IEEE P802.1Qcc D1.1

Reference point for
StartOfInterval – comment #84

Version 01
January 17, 2017

CI 46 SC 46.2.2.5 P143 L44 # 84
Kehrer, Stephan Hirschmann Automatio

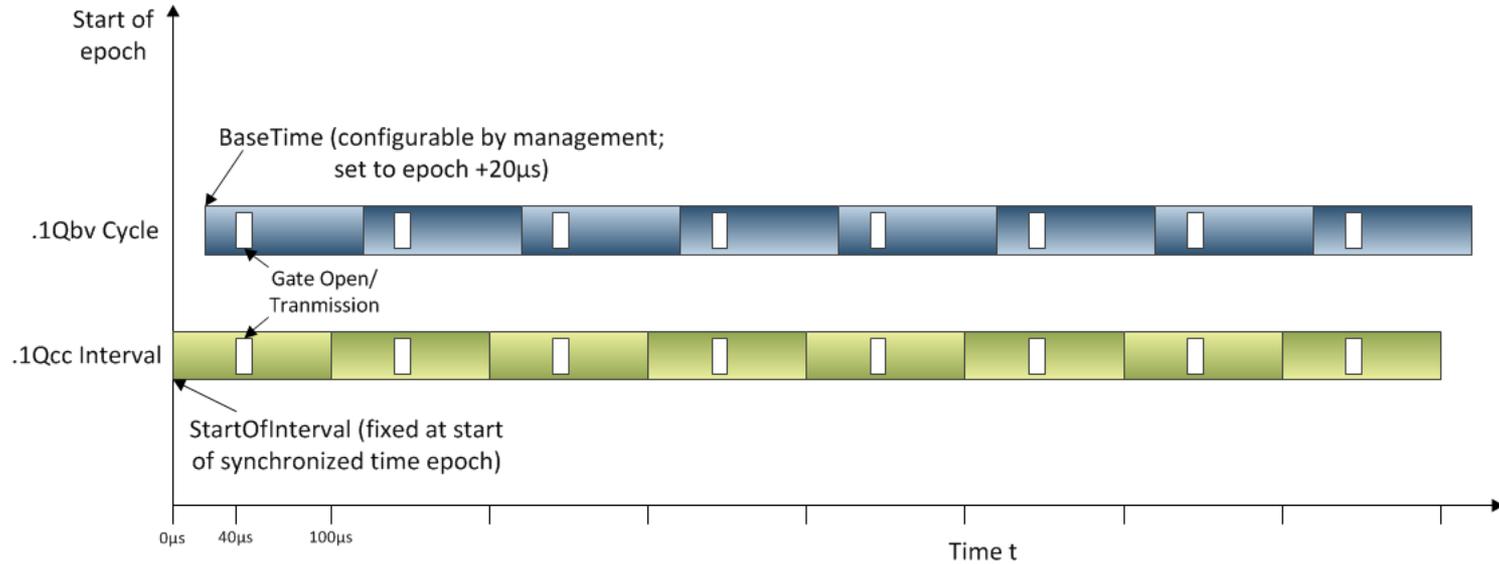
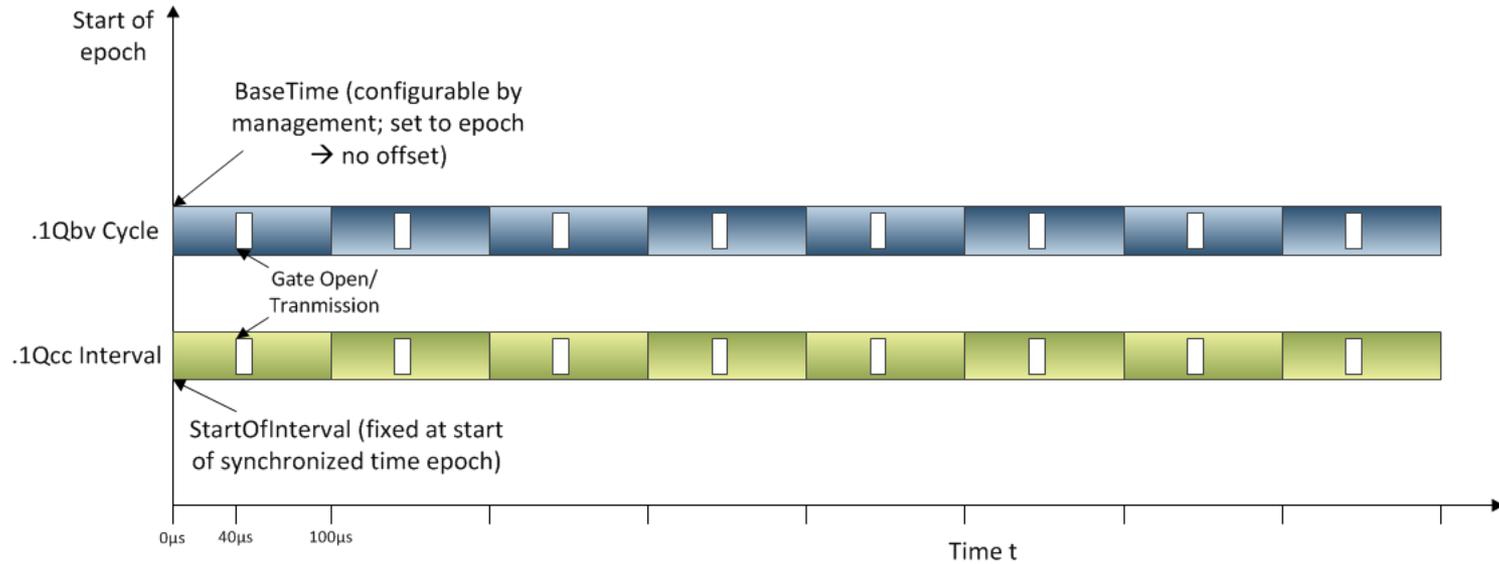
"StartOfInterval" is defined as "StartOfInterval = N * Interval". However, in the descriptive text above it is stated, that it needs to begin in phase with a time epoch. This seems to be missing in the definition in line 44.

- if *BaseTime* in .1Qbv is changed to a value different from 0, the cycles of .1Qcc and .1Qbv are not aligned in time
 - this situation will arise as setting *BaseTime* to the future is useful, e.g. to allow for the network to stabilize before starting TSN transmissions

- significantly increases debugging burden for operators as transmission times of end stations (.1Qcc) and bridges (.1Qbv) do not match
 - e.g. with $\text{OperBaseTime} = \text{epoch} + 20\mu\text{s}$ and $\text{Interval} = \text{OperCycleTime} = 100\mu\text{s}$, a .1Qbv $\text{timeIntervalValue} = 80\mu\text{s}$ (i.e. offset) would map to $0\mu\text{s}$ in next interval of a .1Qcc end station

Change to "StartOfInterval = adminBaseTime + (N * Interval)"

4. Align *.1Qcc Interval* with *.1Qbv CycleTime* by using the *.1Qbv* managed object *OperBaseTime* as an offset for *.1Qcc*
 - **Preferred solution by this commenter**
